ADDENDUM NO. 3

**DATE:** October 5, 2011

**PROJECT:** The New Fairchild Wheeler Multi-Magnet High School  
City of Bridgeport, Connecticut  
State Department of Education Project: # 015-0159MAG/N , Phase 2A

**FROM:** JCJ Architecture, PC  
38 Prospect Street  
Hartford, Connecticut 06103  
(860) 247-9226

1 TYPICAL MAGNET WEST STAIR  
 ELEVATION - WEST AND SOUTH WALLS  
 1/8" = 1'-0"

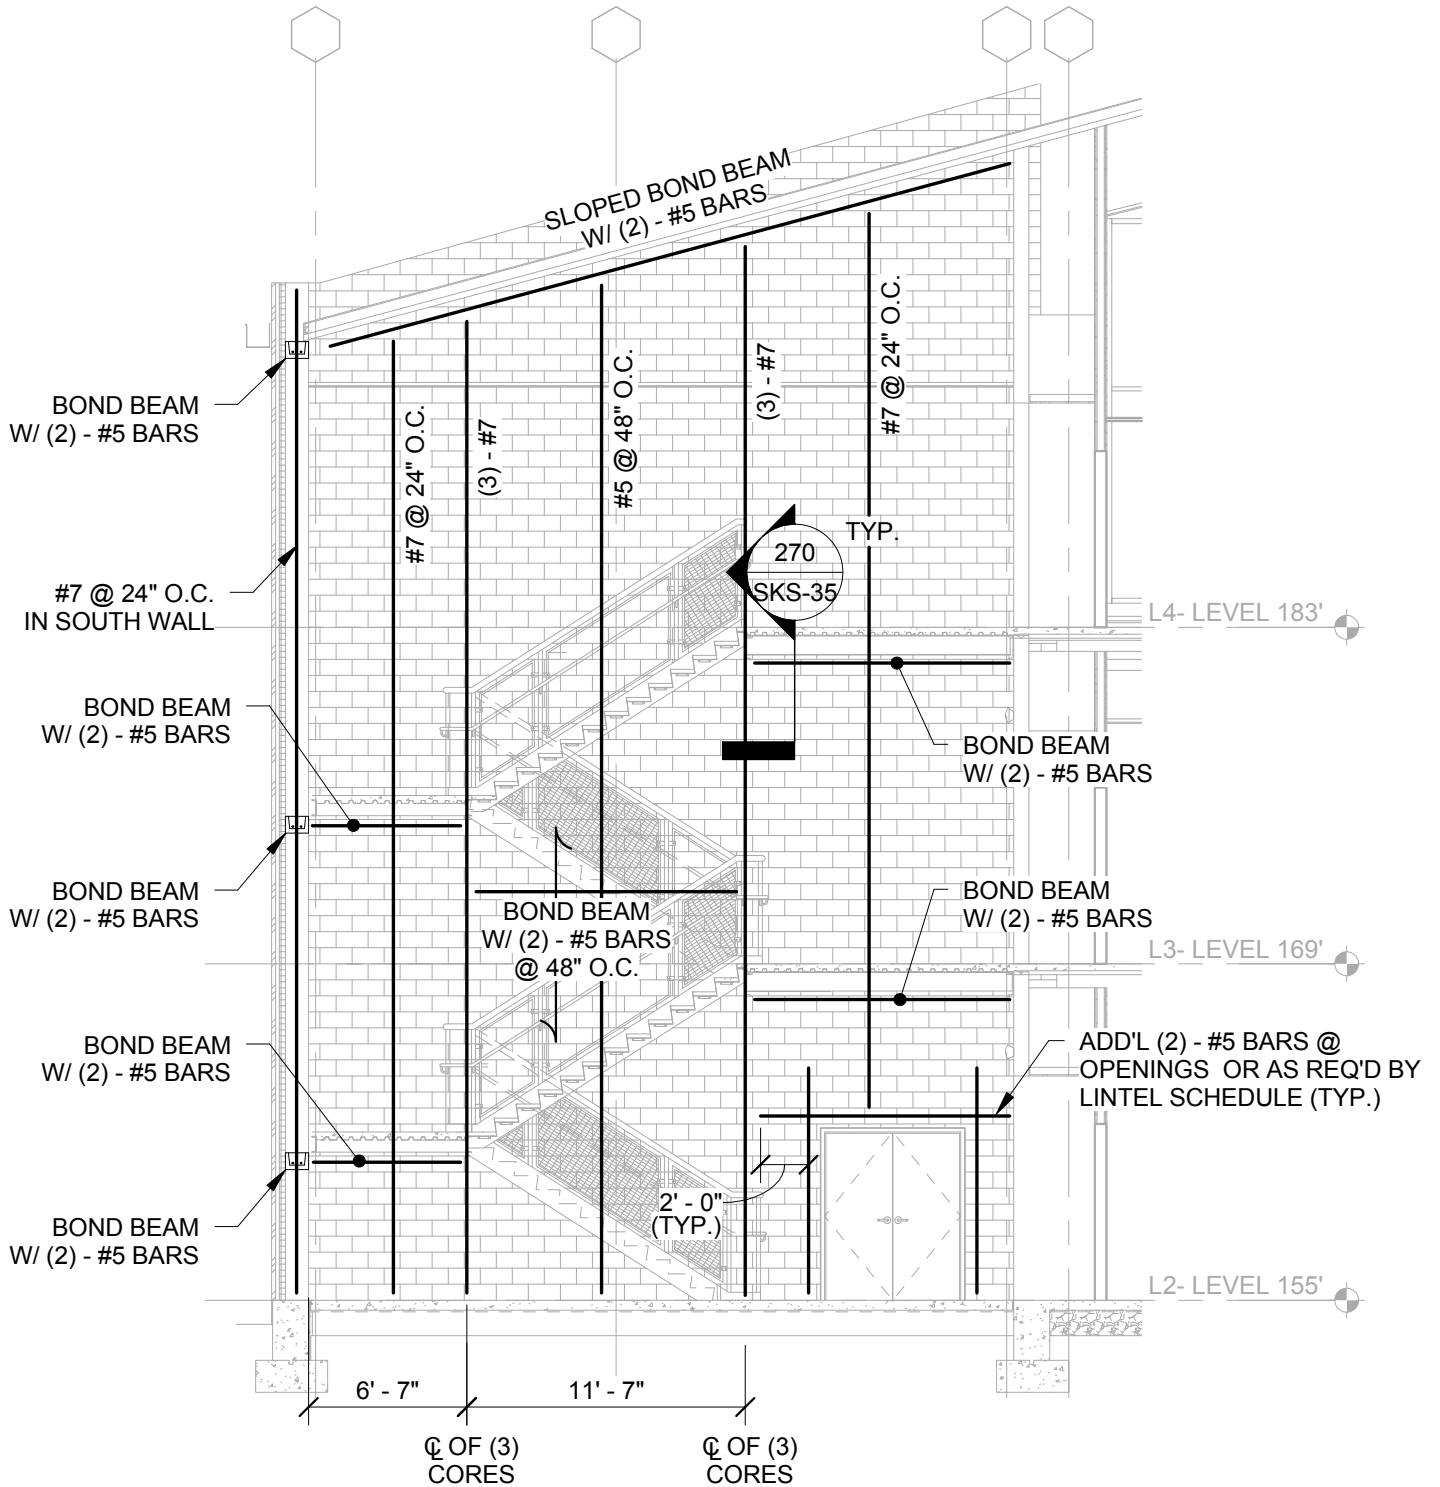
1. **SKS-33** Typical Magnet West Stair, Elevation - West and South Walls.
2. **SKS-34** Typical Magnet East Stair, Elevation - South Wall.
3. **SKS-35** Typical Stair Landing Connection.
4. **SKS-36** Modifications to Masonry Wall Schedule - Reference Drawings S-111 to S-156.

TYPICAL MAGNET EAST STAIR  
ELEVATION - SOUTH WALL  
1/8" = 1'-0"

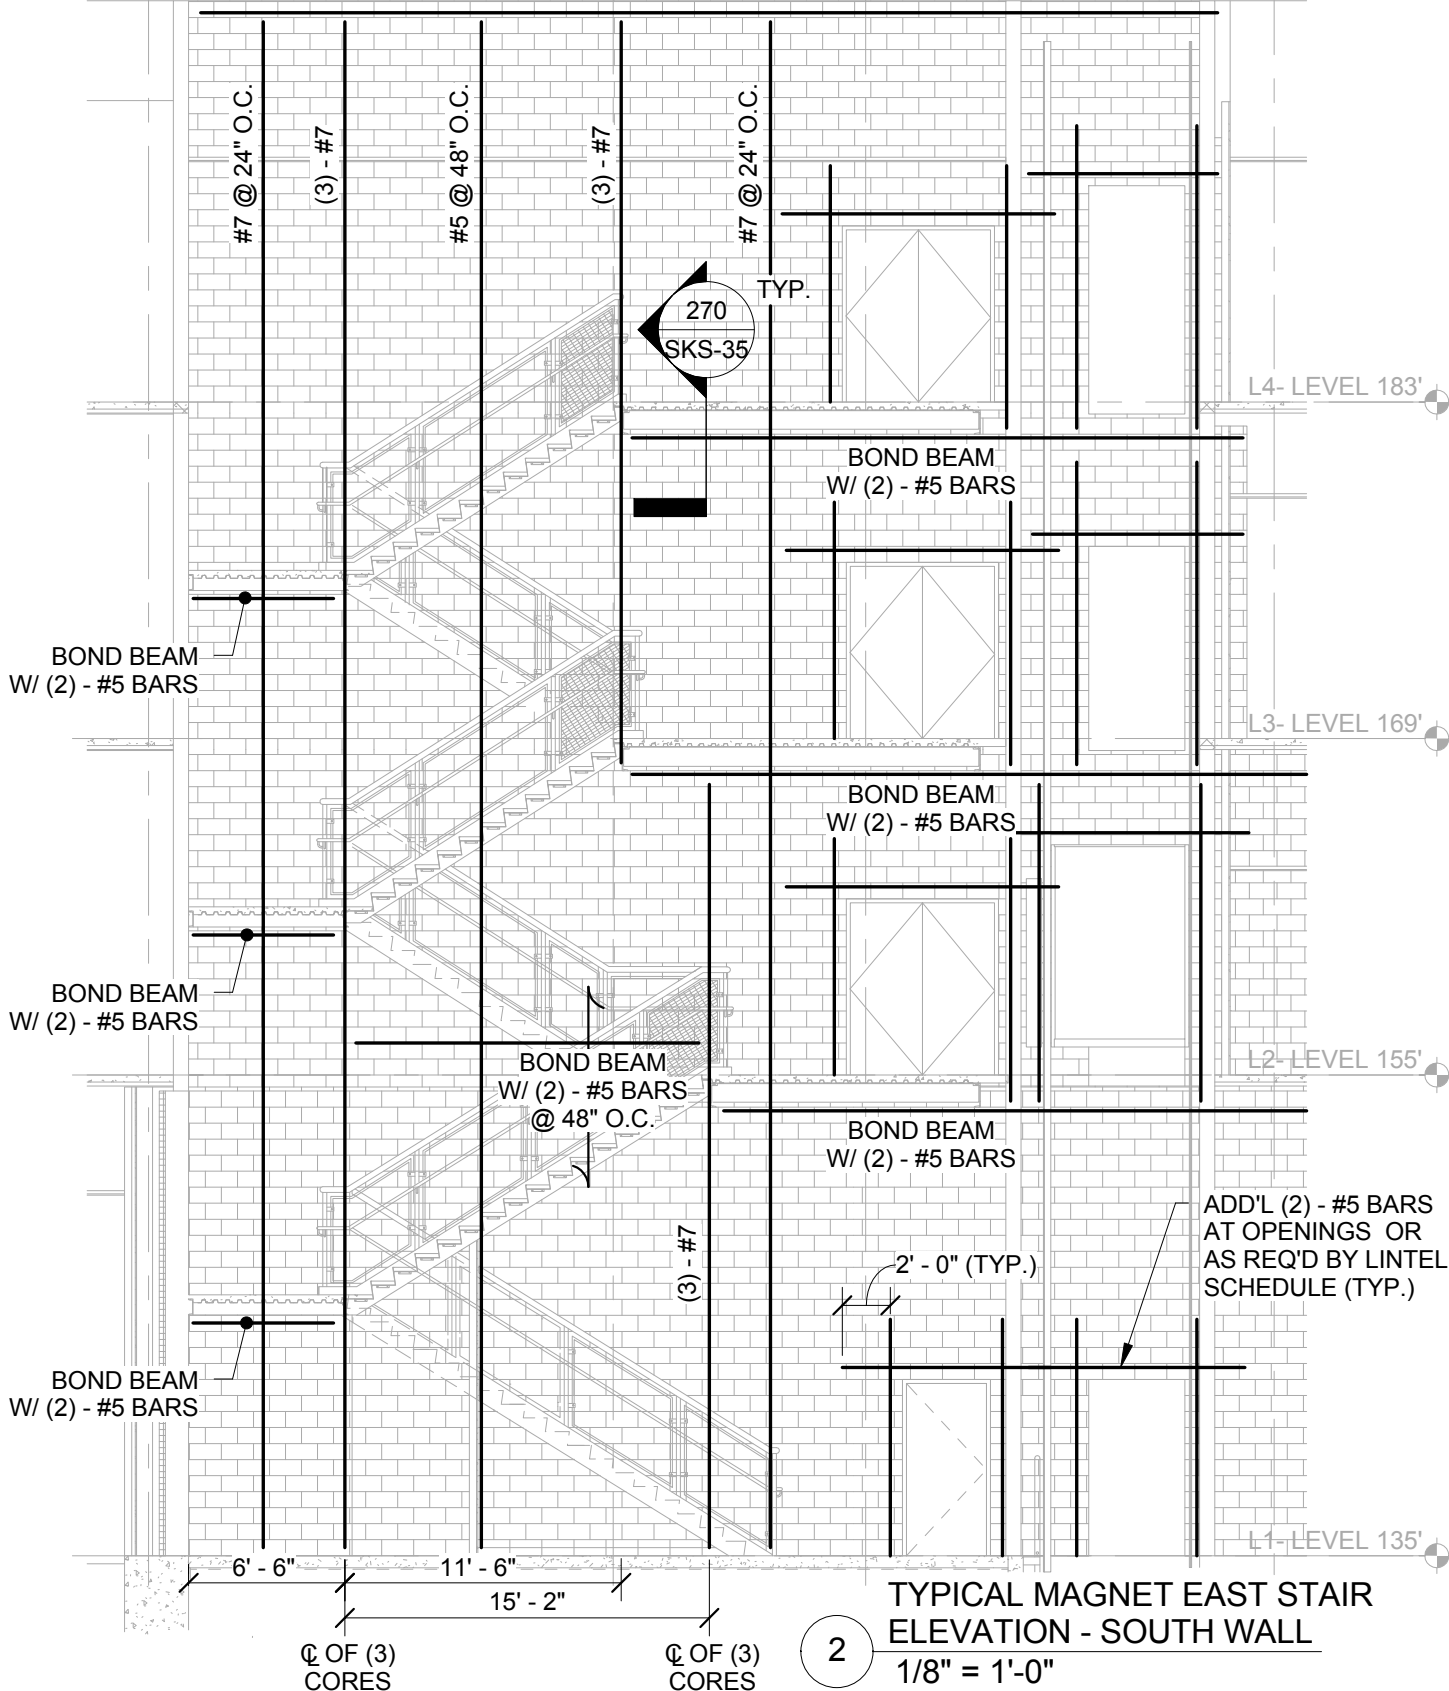
BOND BEAM  
W/ (2) - #5 BARS

270 TYPICAL STAIR LANDING CONNECTION  
3/4" = 1'-0"

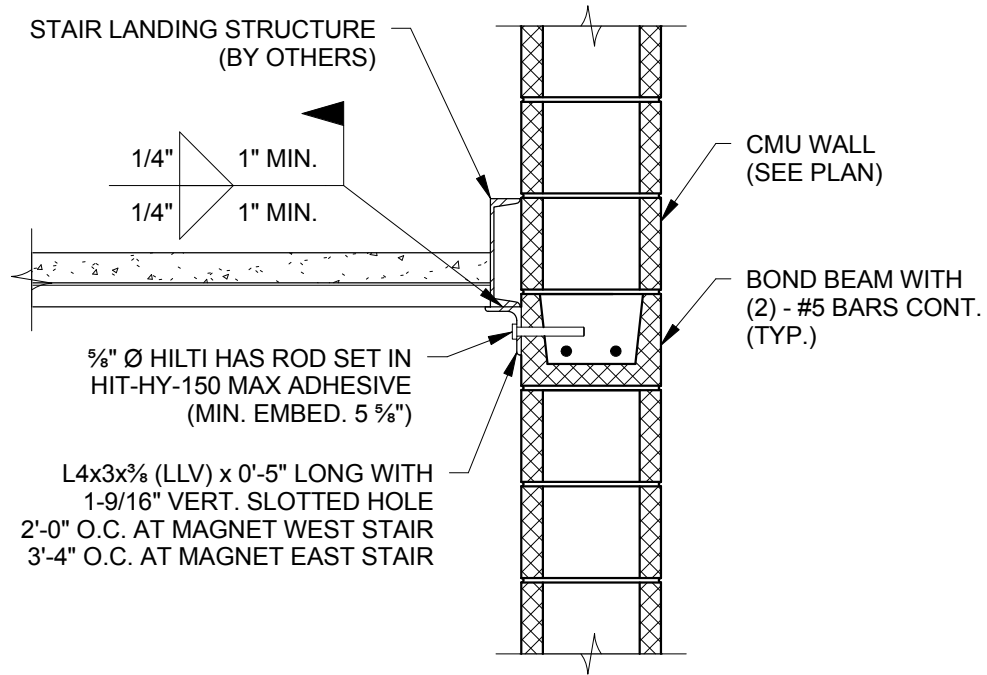
NOTE: TYPICAL ALONG THREE SIDES OF STAIR LANDINGS AT ALL LEVELS.
